HARDWARE UPDATE | JULY 2021

Revision 7 Hardware Update

DMP is now shipping 9800 Series Keypads with Revision 7 hardware (PC-0132 R7).

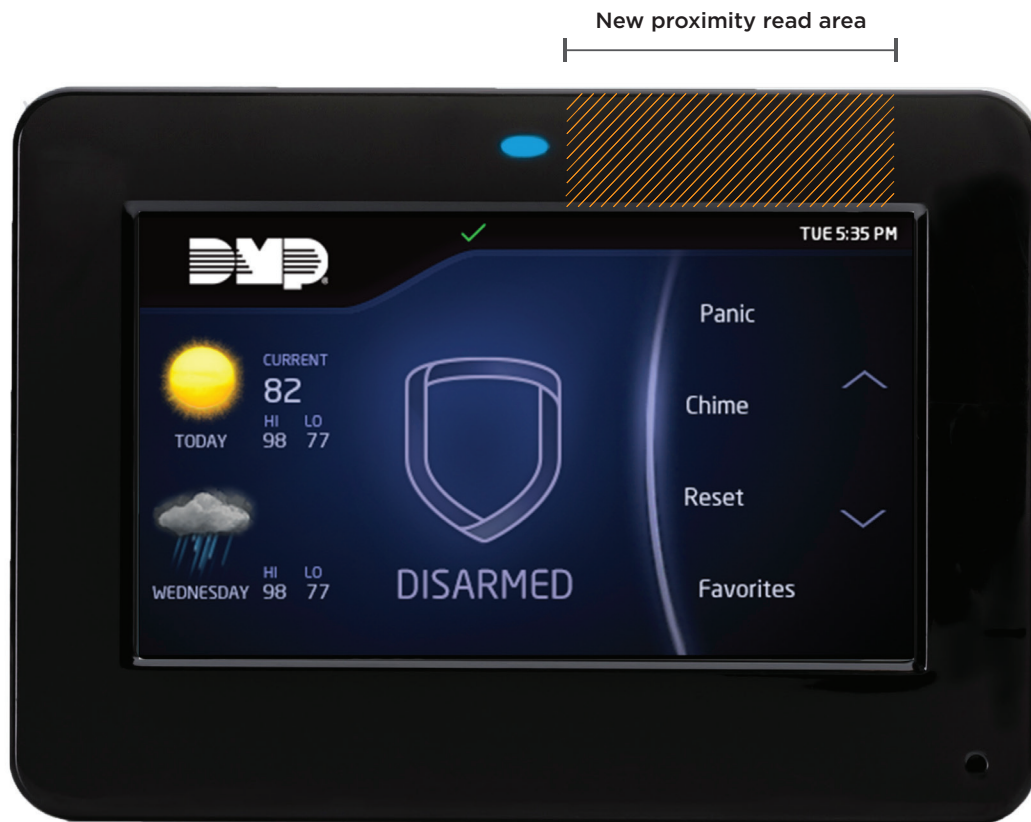
Updated Proximity Reader Antenna

We have updated the keypad prox reader's internal loop antenna with a chip antenna. The placement of the new antenna on the PCB changes where users must present a credential: At the top of the housing, to the right of the keypad LED.
